Mobile People Counting IPC V4.2.2 Firmware Release Notes

Firmware Basic Information	Firmware Version: V4.2.2 build251022
---	--------------------------------------

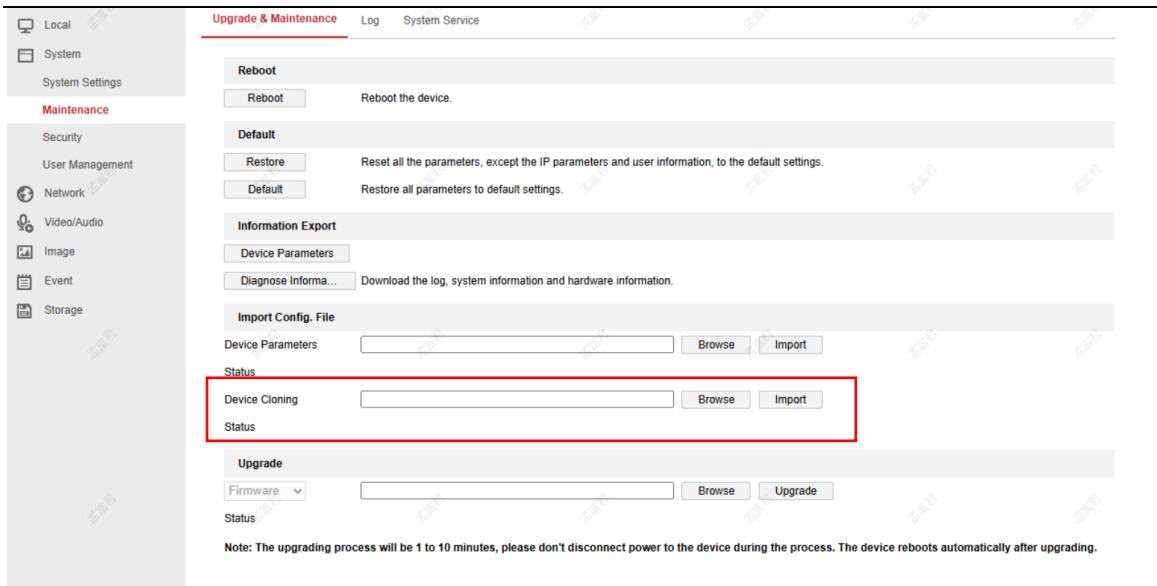
1. Support the counting of special vehicles (bicycle, baby stroller, wheelchair).

Enable Bicycle Counting

Enable Wheelchair Counting

Enable Baby Stroller Counting
